[Docket No. FAA-2025-2546; Project Identifier AD-2025-01060-T; Amendment 39-23414; AD 2026-15-02]

Airworthiness Directives; The Boeing Company Airplanes

Final rule.

Figure 2 to paragraph (i) – Fuel Feed Encapsulation

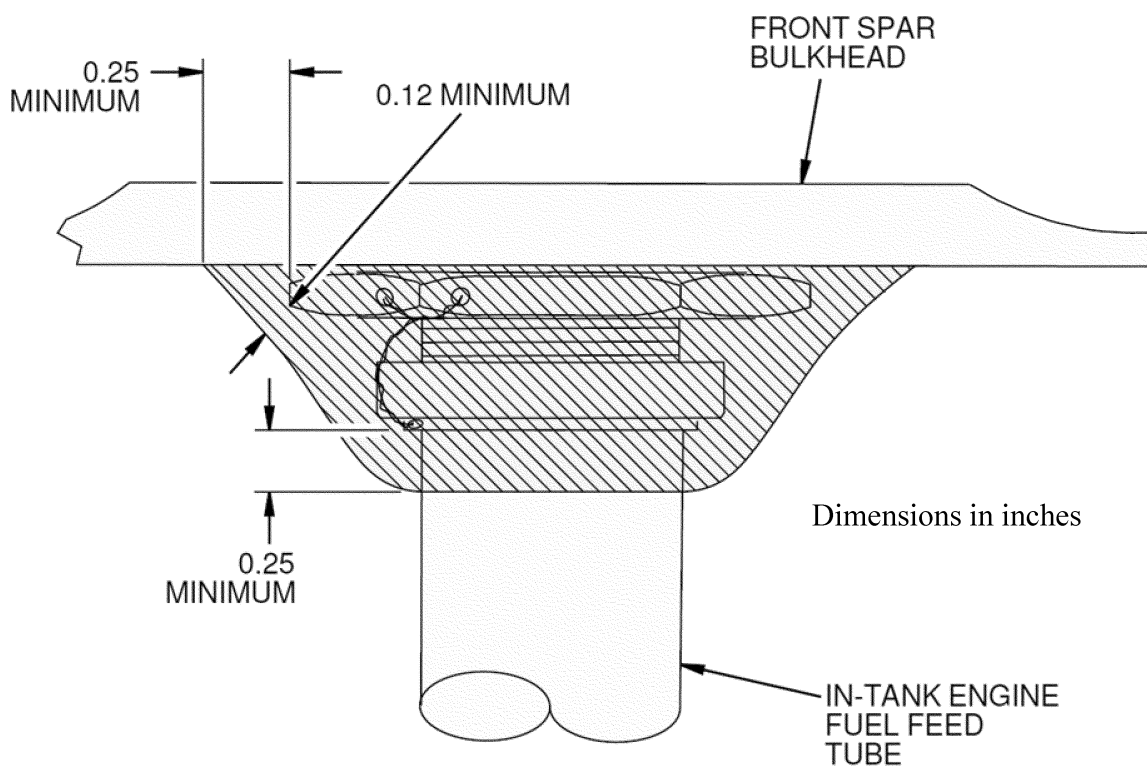
Within 60 days after the effective date of this AD, revise the existing maintenance or inspection program, as applicable, to incorporate the information specified in Figure 1 and Figure 2 to paragraph (i) of this AD.
